Tween Bridge Solar Farm

Environmental Statement
Appendix 10.1: Flood Risk Assessment
Part 2

Document Reference: 6.3.10.1

Appendix E – Indicative Operational Layout Plan and Indicative Layouts and Cross Section Plans

Figure 2.6: Indicative Layout and Cross Section Plans
Drawing Ref: Typical Customer Switchgear

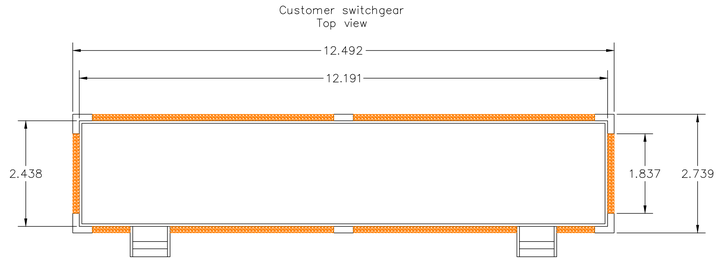
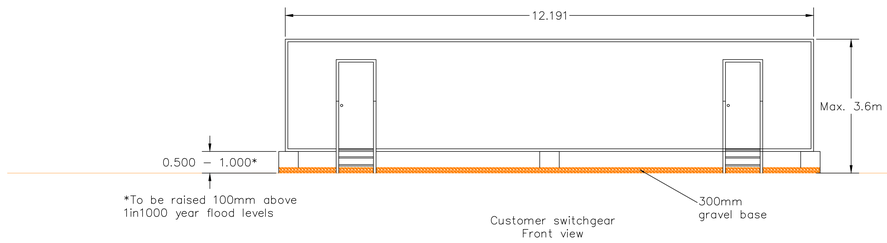
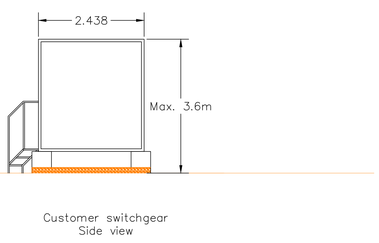
As mentioned above, providing there is no raising of ground levels and panels and structures can be raised to allow the free flow of floodwater across the floodplain then this will be acceptable. We are slightly concerned that the proposed customer switchgear structures will not however maintain the raising of the floor level to 100mm above the 1 in 1000 year floodplain depths. The battery containers show that these will be raised sufficiently but this is not maintained for the switchgear. Is there a reason for this?

Following on from my email below, please see attached updated ancillary drawing pack. This now shows the correct raising for the switch gear structures.

Figure 2.6: Indicative Layout and Cross Section Plans
Drawing Ref: Typical Fence Detail - Ditch Crossing

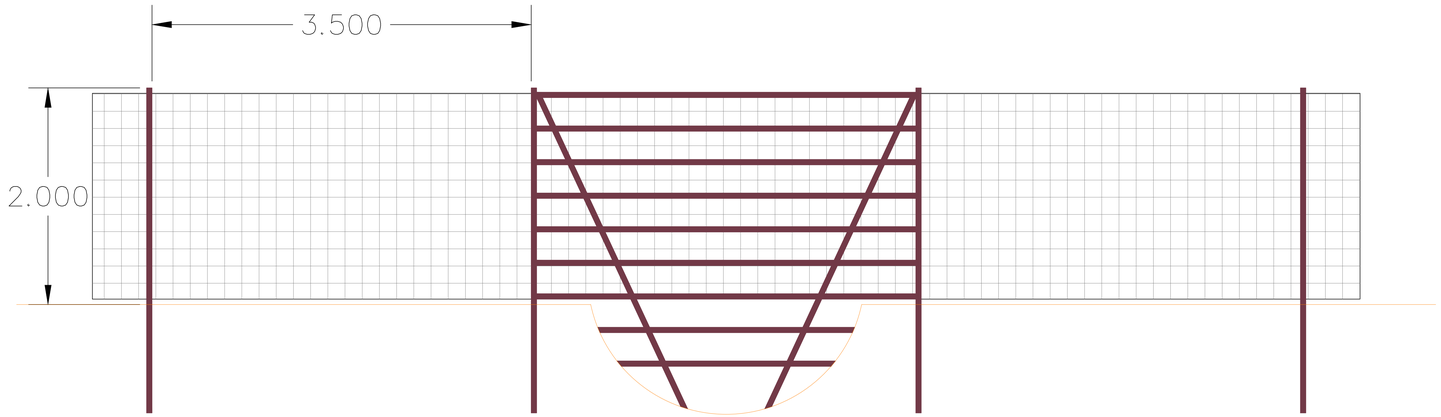
- The proposed method of fence crossings over ditches on site is also included in the ancillary drawing pack. We would welcome your comments on these proposals.

We cannot comment on whether these will be allowed, as these are not proposed on main rivers where we would normally insist on a FRAP. However, any fencing proposed within the floodplain should have a sufficient grid size if this is for the proposed mesh fencing or gaps for the proposed ditch crossing metal work, to allow the free flow of water across the floodplain. We would wish to see the proposed maintenance plan to provide comments on the proposals. Regular inspections of the fencing and grates should be undertaken to clear any debris which may have become snagged and could present a diversion in floodplain flows.

Figure 2.6: Indicative Layout and Cross Section Plans
Drawing Ref: Typical Non-Intrusive Cable Crossing

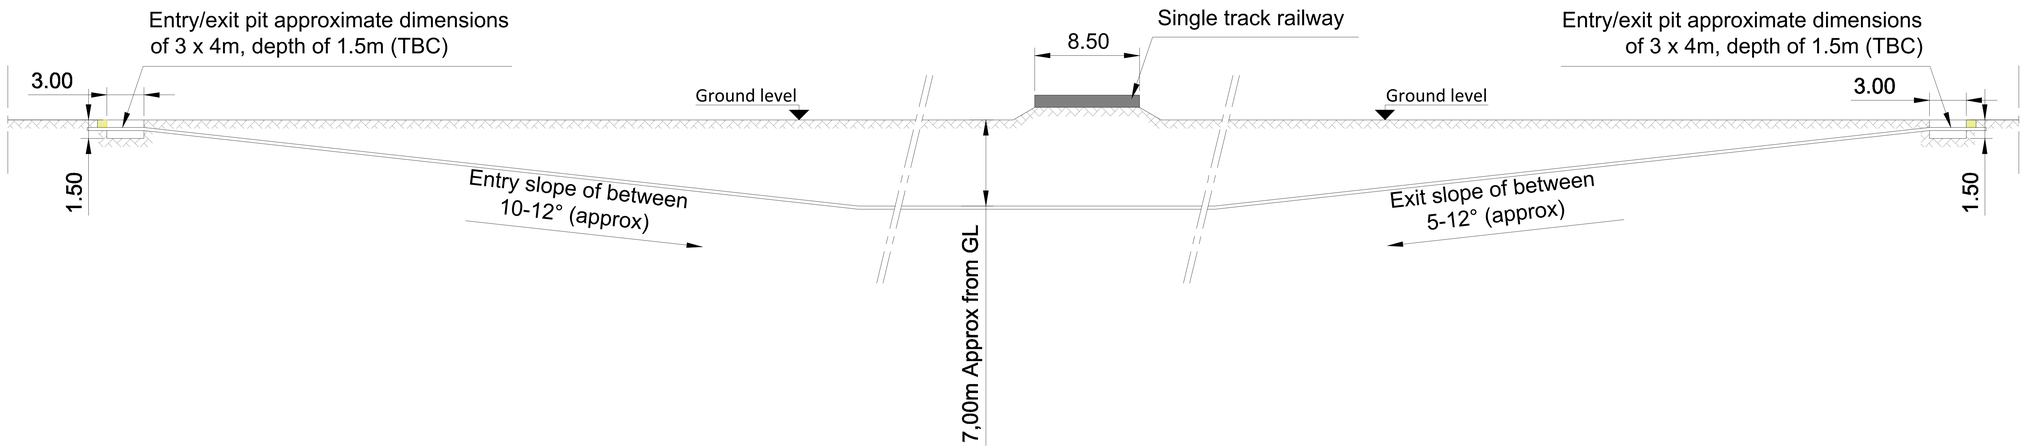
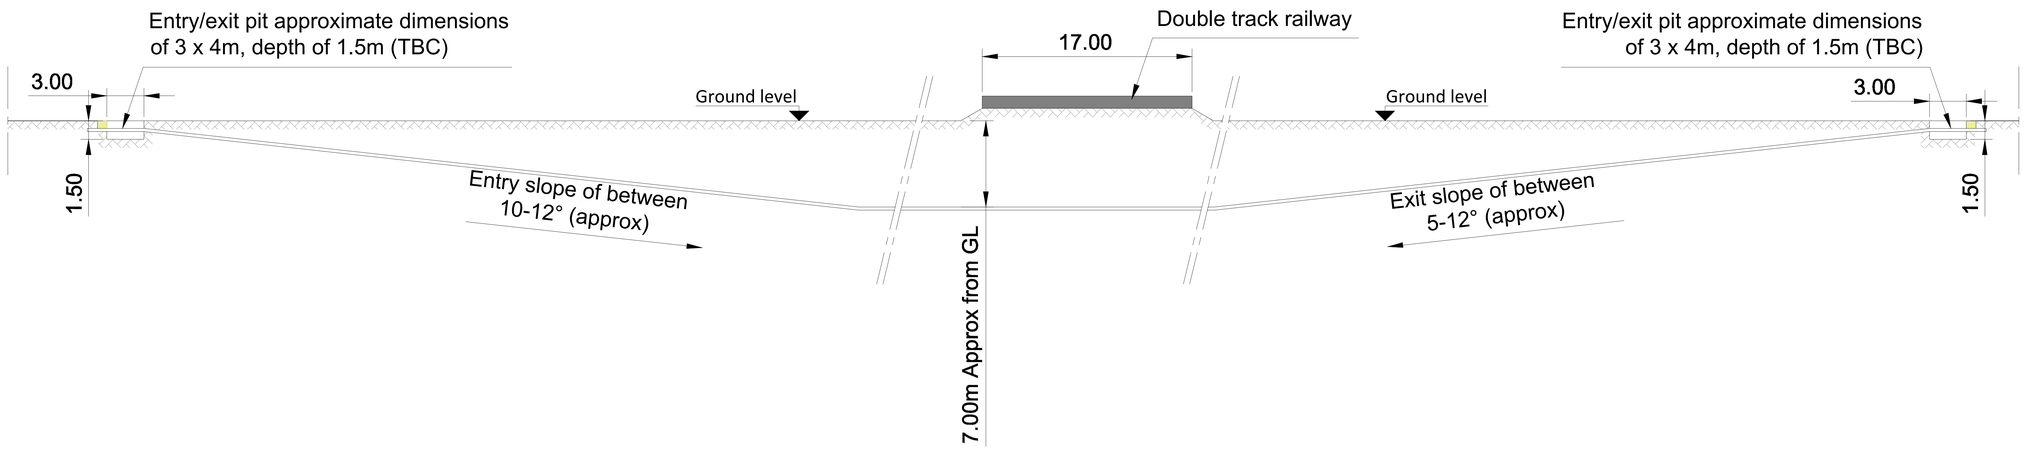
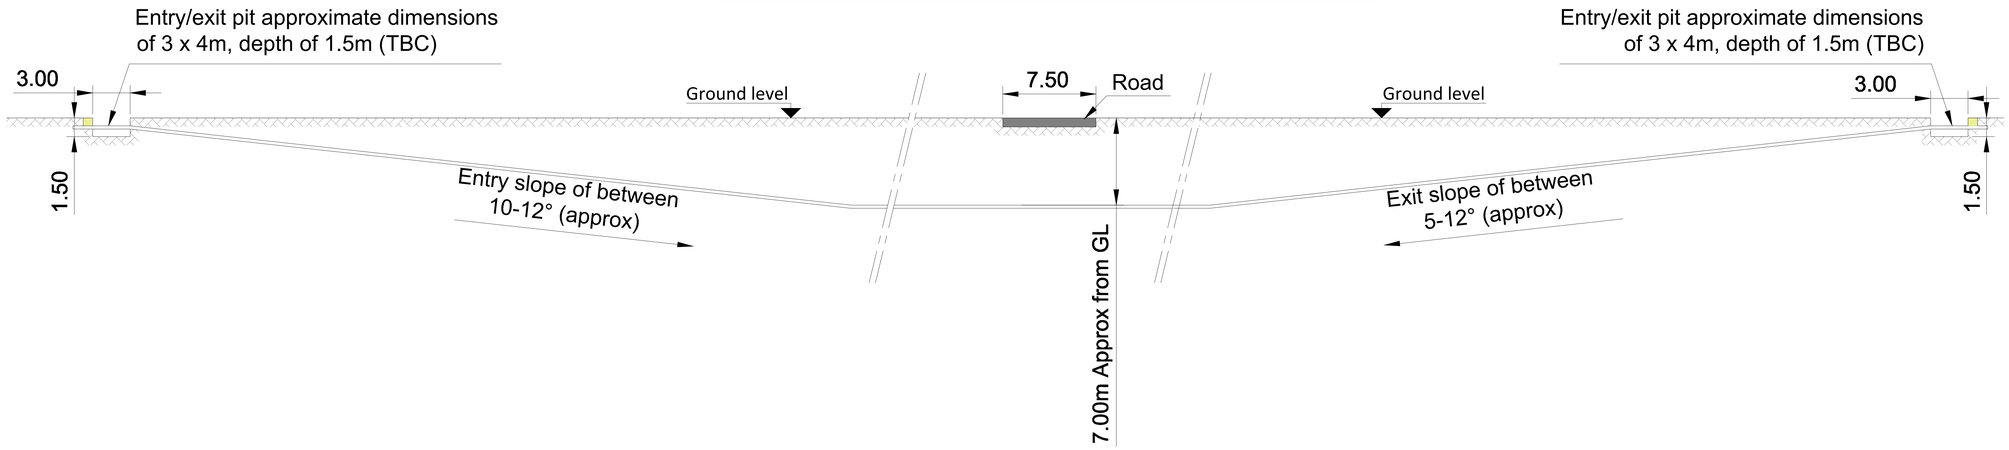
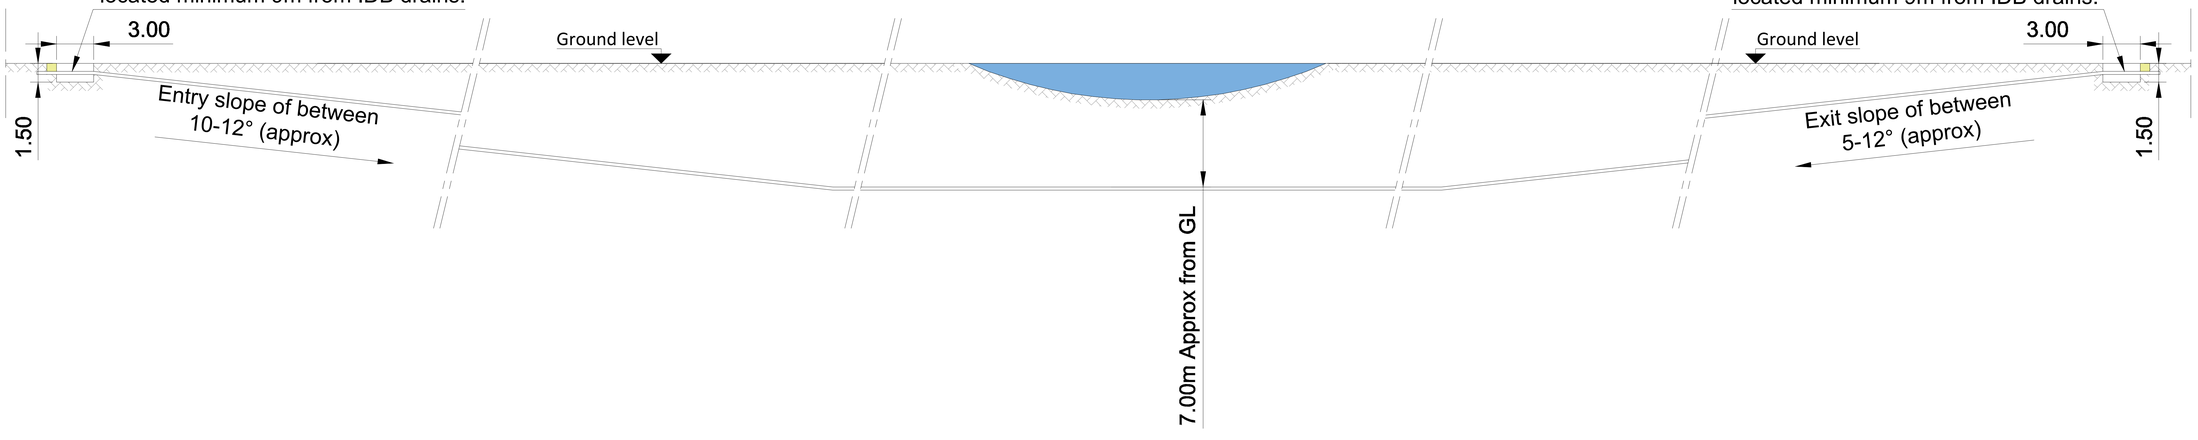
- The latest site layout plan linked above includes location of where cable route crossings are currently proposed (shown by yellow squares). The ancillary drawing pack includes typical plans of the proposed cabling methods for different scenarios. We would welcome your comments on these proposals.
